REMARKS

ANNOTATED MARKED-UP DRAWINGS

FIG. 1

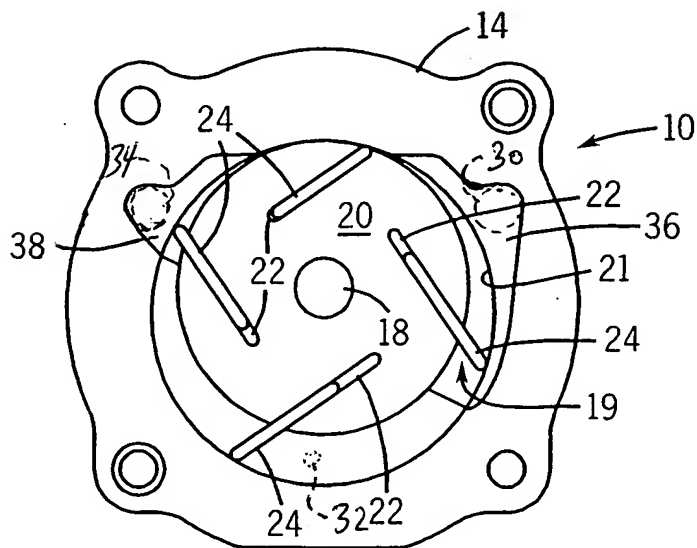
The above action indicated that the drawings were objected to because of the issues raised in the first three paragraphs of page 2. In particular, the drawings were objected to because ports 30, 32 and 34 were not shown in Figure 1, and reference numerals 40, 42, 56, 58, 60, 62 and 64 were not shown in Figure 3. Also, the drawings did not show the filter element recited in the claims.

The enclosed drawing sheets titled "Annotated Marked-up Drawings" include proposed changes to Figures 1, 3 and 4 shown in red to add the noted reference numbers to Figures 1 and 3 and to add a filter --74-- to Figure 4. A new set of formal drawings is also enclosed with each sheet titled "Replacement Sheet".

FIG. 3

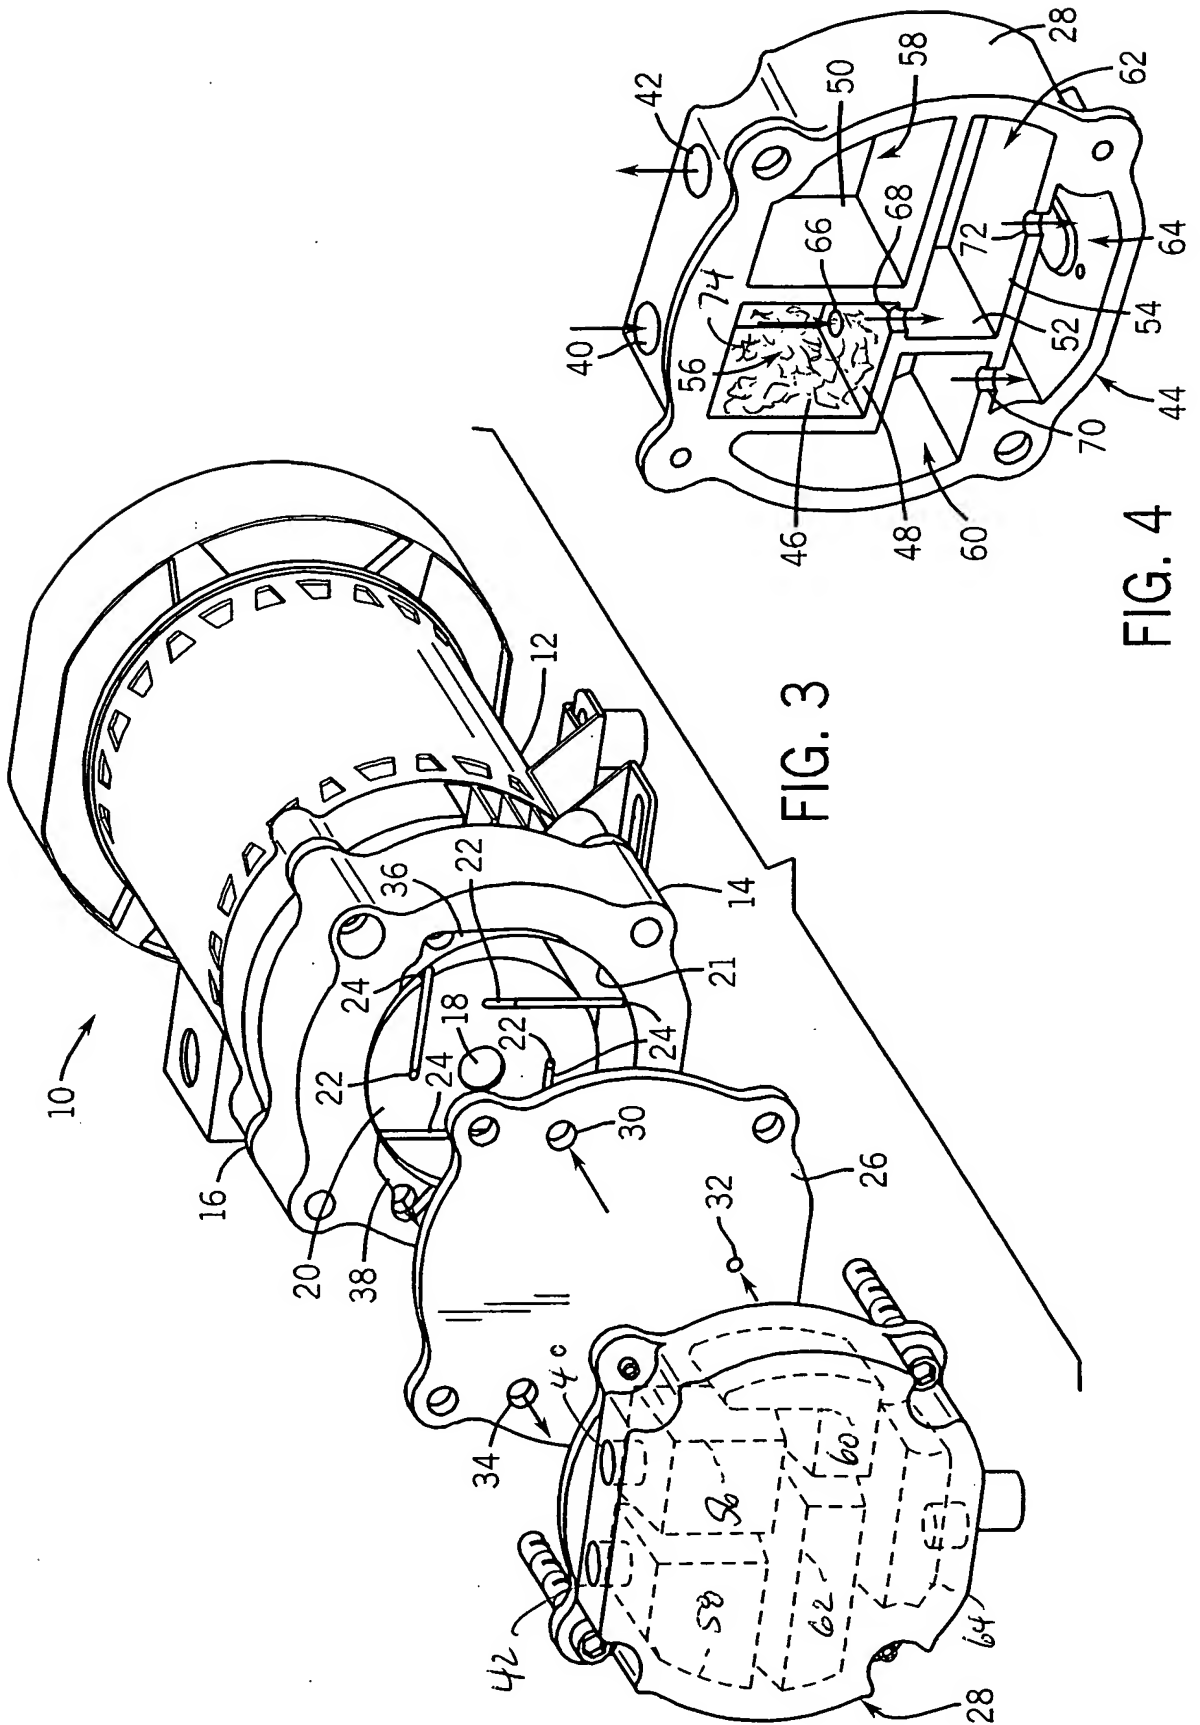
In addition, claims 9 and 10 are being presented herein to recite a more particularly defined location for the secondary inlet port. Amended Figure 1 and Figure 3 illustrate how a rotating vane chamber passing by a preferred location of the secondary inlet port has a leading vane that moves inwardly and a trailing vane that moves outwardly for at least part of the time the secondary inlet port is in communication with that vane chamber. These claims depend from respective amended independent claims 1 and 8 and are believed patentable for the above reasons as well as for the additional distinguishing features claimed therein.
